DEVELOPMENT REVIEW BOARD

Planning - Case Comments

Project Number: PR-2022-006939

Project Name: American Gypsum

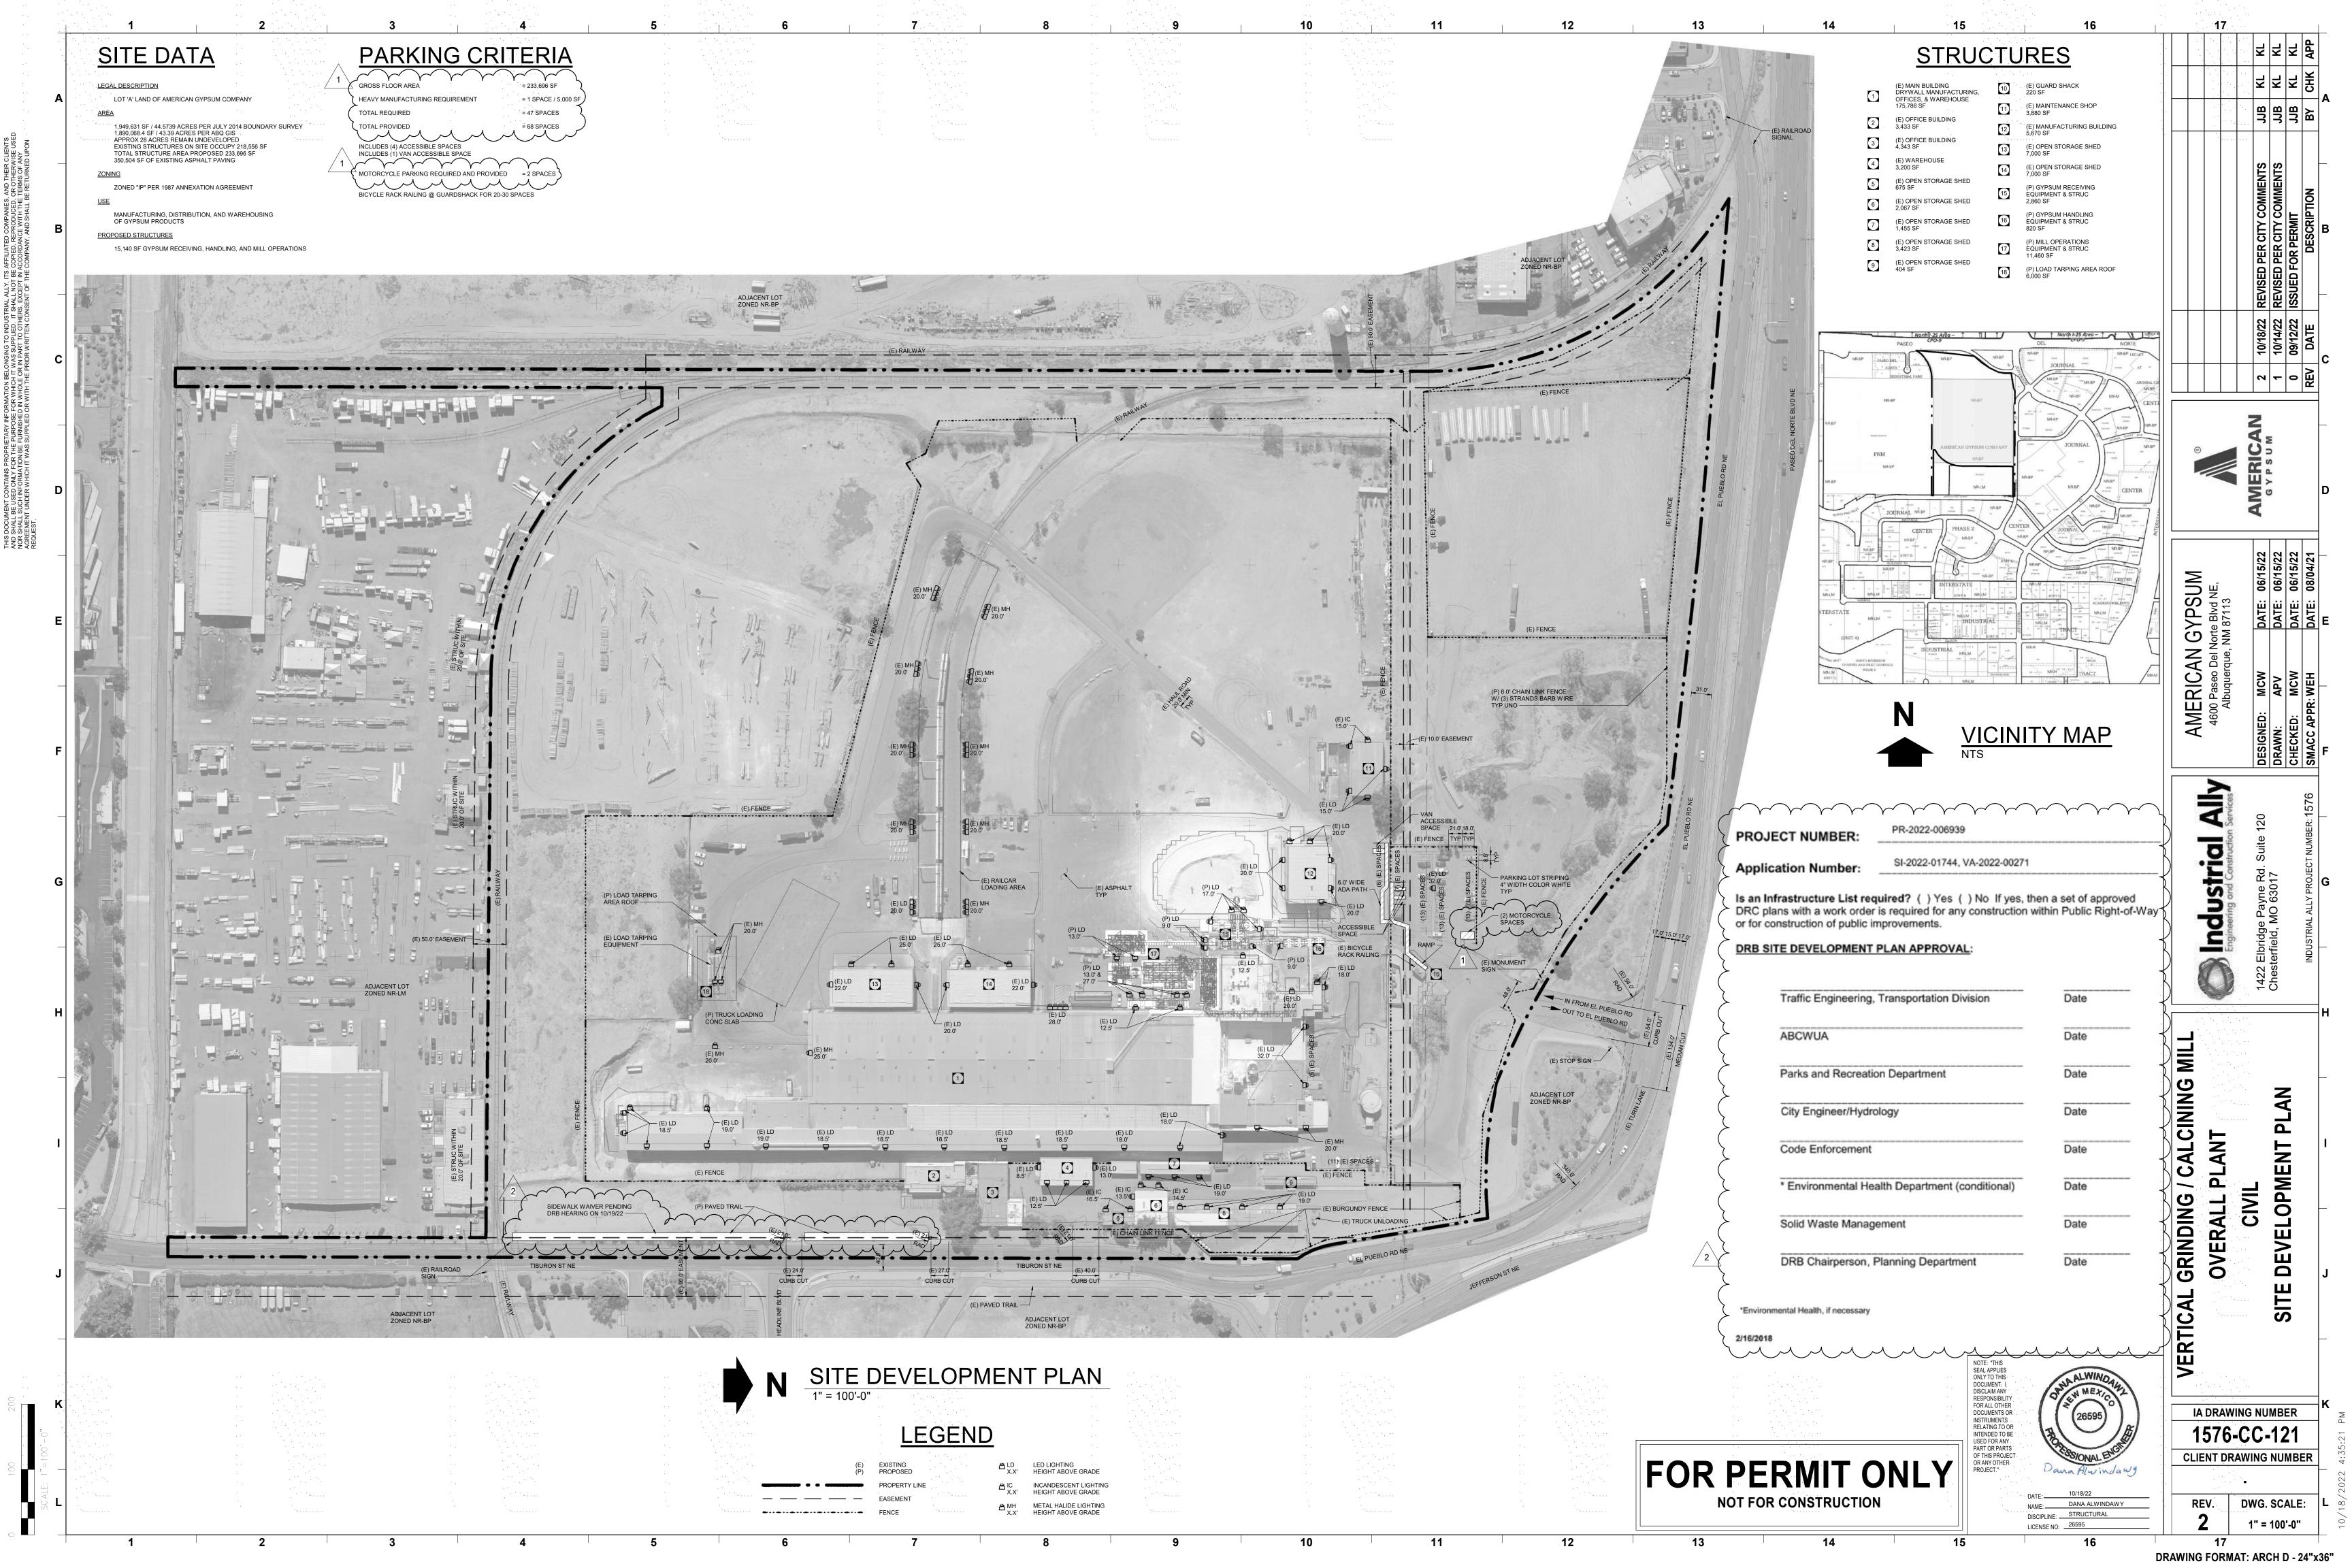
- An Infrastructure List is included with the Site Plan Amendment. A recorded IIA must be submitted prior to final sign-off from Planning.
- The application number for the Site Plan Amendment must be added to the Infrastructure List, the legal description for the site must be added to the Infrastructure List, and the Infrastructure List must be signed and dated. The application number and legal description has been added to the Infrastructure List. Please see updated List below.
